**NESHAPS SUBPART DDDDD
HEALTH-BASED COMPLIANCE
ALTERNATIVE DEMONSTRATION
FOR
SMURFIT-STONE CONTAINER ENTERPRISES, INC.
*FERNANDINA BEACH MILL
FERNANDINA BEACH, FLORIDA***

From: Morris.Mark@epamail.epa.gov
Int: Tuesday, March 06, 2007 11:01 AM
To: Phillips, Cindy
Cc: Holladay, Cleve; AlNahdy, Khalid; Hirtz.James@epamail.epa.gov
Subject: Re: FW: Boiler MACT HBCA Smurfit-Stone Container 06FL

**RE: SMURFIT-STONE CONTAINER ENTERPRISES, INC.
FERNANDINA BEACH MILL
HBCA TITLE V PERMIT REVISION APPLICATION
REQUEST FOR ADDITIONAL INFORMATION**

TITLE
**Receptor Grid Locations
 Overlaid on an Aerial Photograph**

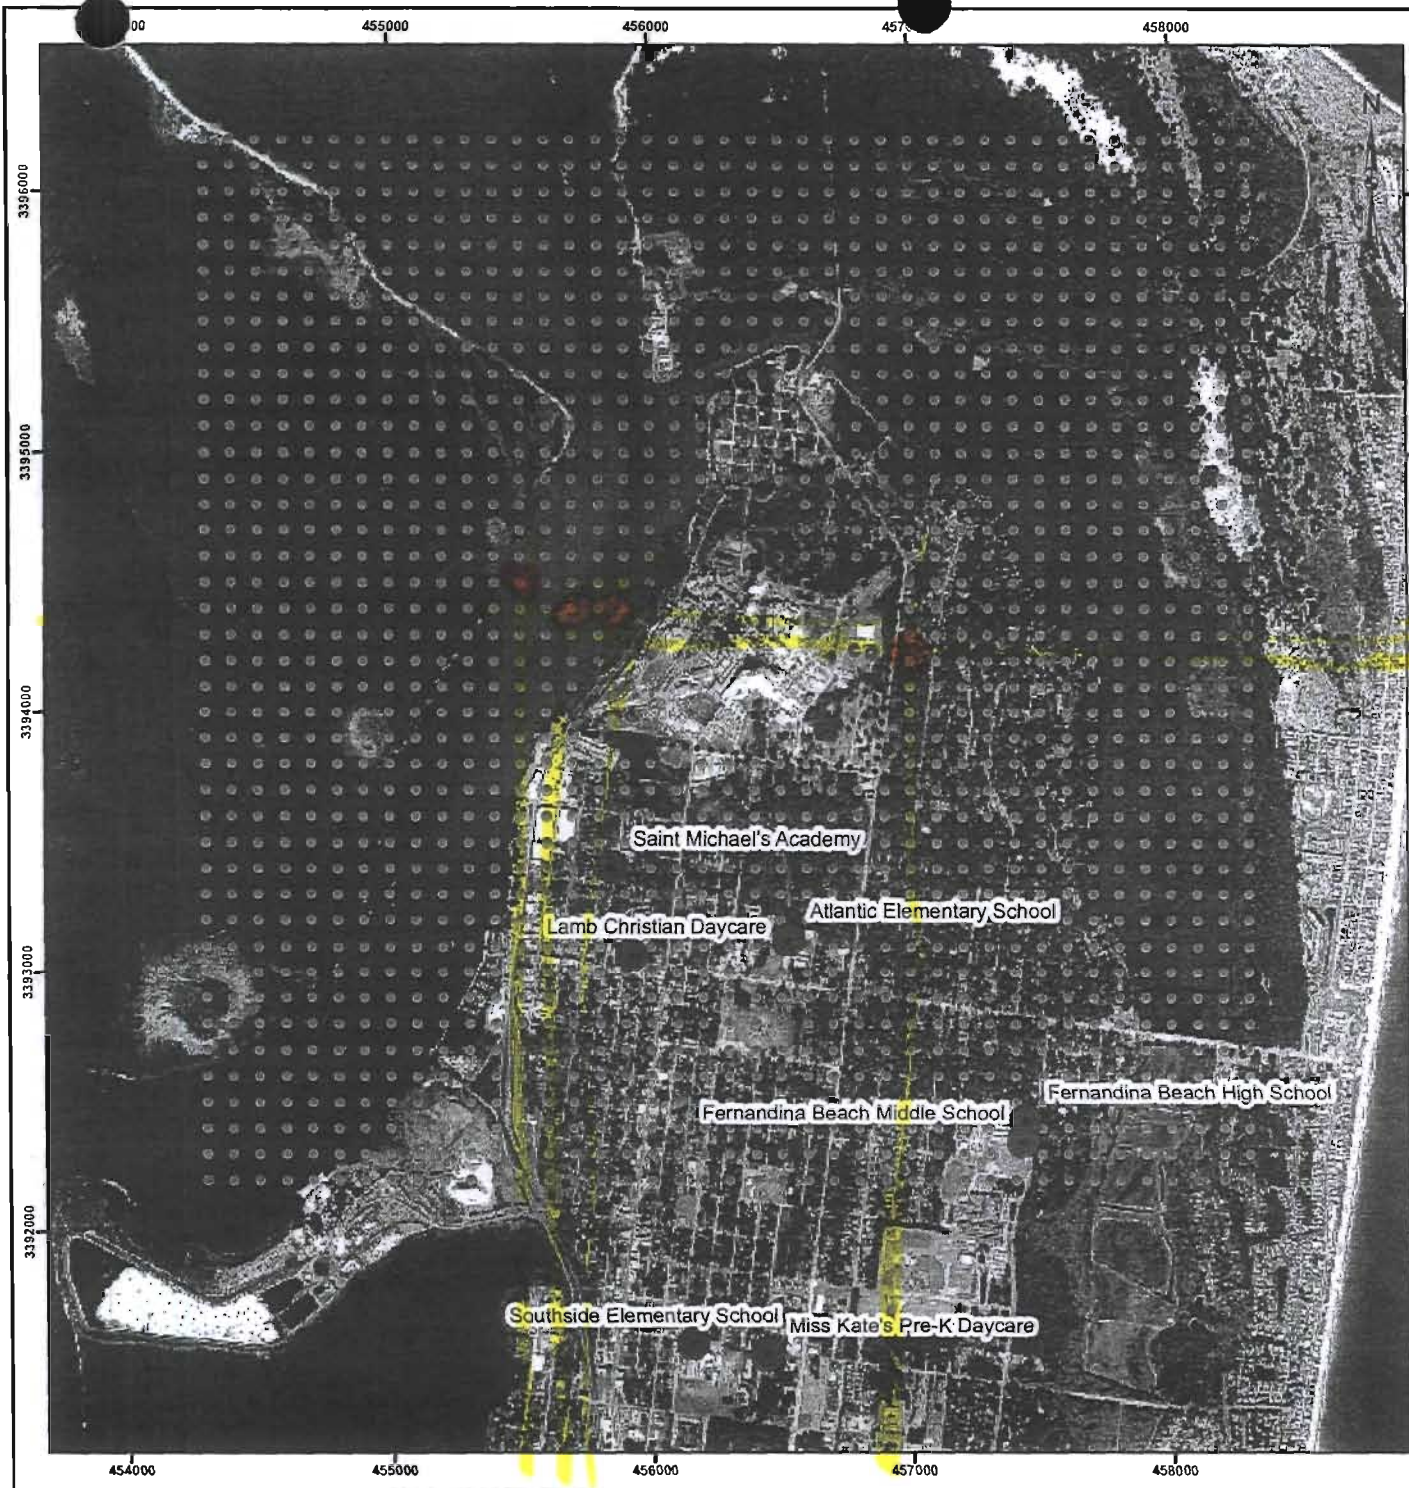
Comment 3. In Figure 3-2 Receptor Grid Locations, please indicate what are the sensitive receptors (for example, school, daycare, senior community, hospital).

Response: The area covered by the receptor grid in Figure 3-2, Receptor Grid Locations, contains a few sensitive areas, namely schools. A new figure, Figure A in Attachment C, Receptor Grid Locations and Sensitive Areas, has been developed to show the proximity of the sensitive areas to the fence line. The only sensitive receptors are seven schools, identified in the figure, with the nearest school, Saint Michael's Academy, located approximately 500 meters from the fence line.
